Montecillo Unit Eight Replat "A"

City Plan Commission — May 8, 2025 **REVISED**

CASE NUMBER/TYPE: SUSC25-00001 – Resubdivision Combination
CASE MANAGER: Armida R. Martinez, (915) 212-1605, martinezar@elpasotexas.gov
PROPERTY OWNER: EPT Mesa Development, LP
REPRESENTATIVE: Brock & Bustillos
LOCATION: South of Castellano Dr. and West of Mesa St. (District 8)
PROPERTY AREA: 5.96 acres
VESTED RIGHTS STATUS: Not Vested
PARK FEES: Park Fees Not Required
ZONING DISTRICT(S): SCZ-T40 (SmartCode; Transect 40) and SCZ -T1 (SmartCode; Transect 1)

SUMMARY OF RECOMMENDATION: Staff recommends **APPROVAL WITH A CONDITION** of Montecillo Unit Eight Replat "A" on a Resubdivision Combination basis. The condition is as follows:

Figure A: Proposed plat with surrounding area

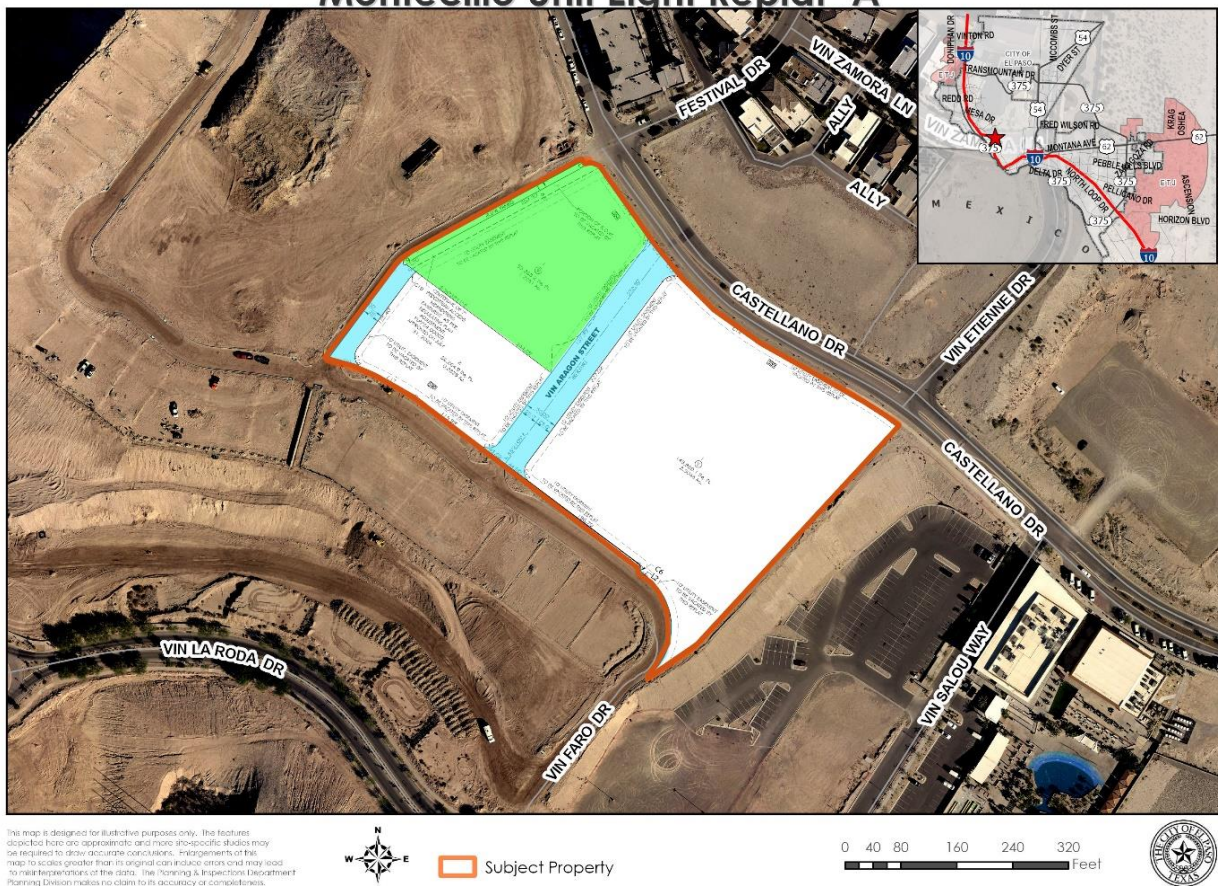
3. Vin Faro Lane includes two cross-sections with different proposed transition widths; however, these are not reflected on the plat. The plat currently indicates on a 50' ROW width.

7. Lot number on the preliminary plat is not clearly legible – please ensure they are distinguishable.
8. Revise the preliminary plat showing the improvements.

14. Specify the location of meandering sidewalk easement.
15. Add C24 information to the curve table
16. Provide hatch line for area being vacated.

- That the Montecillo Regulating Plan be adjusted to match the proposed street cross-sections prior to recording of the final plat.
